Submission of updated information pursuant to Reserved Matters application (Ref. DC/26/0682) on Land at Hurst Farm, Hurstwood Lane, Haywards Heath, West Sussex.

Following a review of comments received to date on the aforementioned reserved matters application, we have sought to address these through the following changes:

KEY

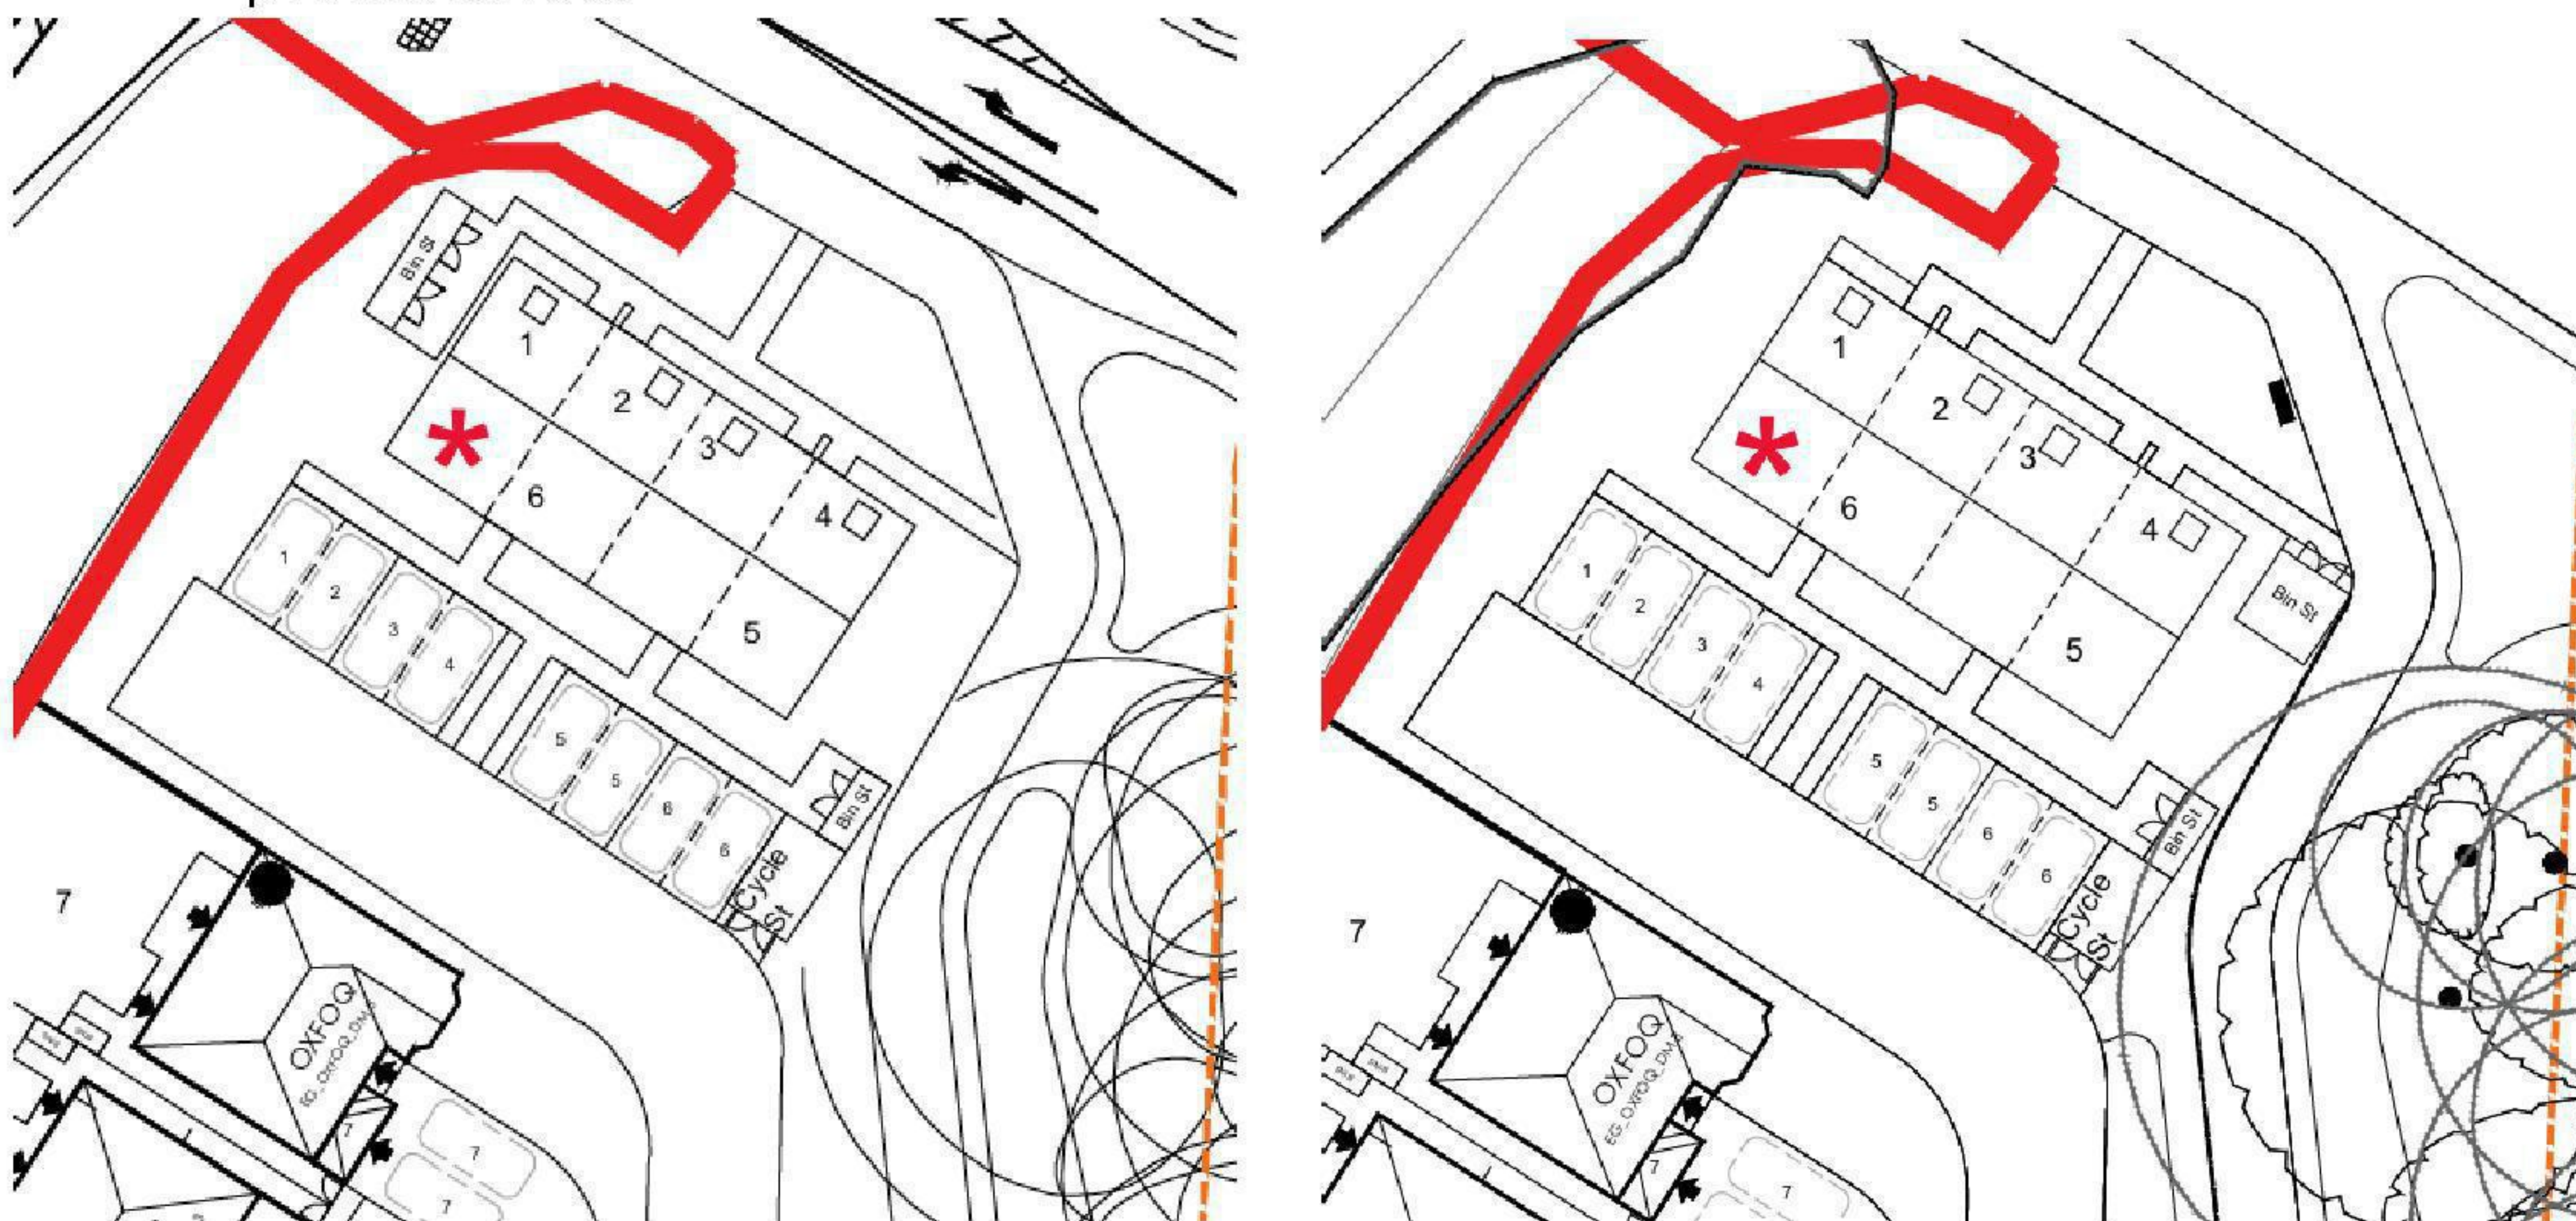
5. Courtyards updated to be contained by brick screen walls as requested by Place Services Landscaping team.

-  1800mm Redrow Brick Wall 01
(Brick wall to match with adjacent House Material)
-  1800mm Barratt/David Wilson Brick Wall Type 3
(Brick wall to match with adjacent House Material)
-  600mm Vertical Metal Railing
-  600mm Redrow 600m High Wall with 600mm High Railings (TBC)
-  600mm Knee Railing around SUDS (TBC)
-  1800mm Close Board Timber Fence
